## SUBMISSION ON ACT WATER SENSITIVE URBAN DESIGN REVIEW 2013

## Supplement showing good and poor implementation of water sensitive urban design on road edges

Gillian King

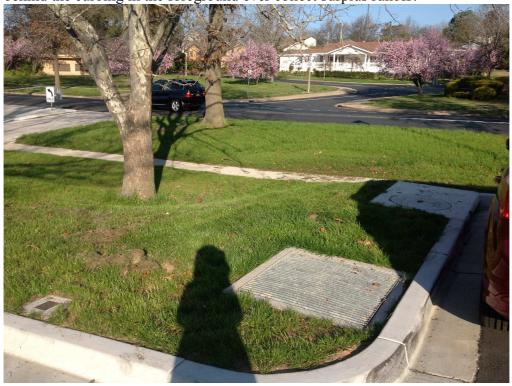
Example 8: Red Hill (Red Hill Primary School) – carpark constructed in manner that directs water away from trees. This carpark was built above the previous (probably natural) level of the land. It was hard-paved and continuously curbed. These measures rob the existing mature trees of water to which they previously had access via a grass surface. (September 2013)

The continuous curbing feeds rainwater into the underground stormwater system. How much better for the trees and budget would it have been to have broken curbing feeding water to the trees? And how will the very highly-placed stormwater pit behind the curbing in the foreground ever collect surplus runoff?
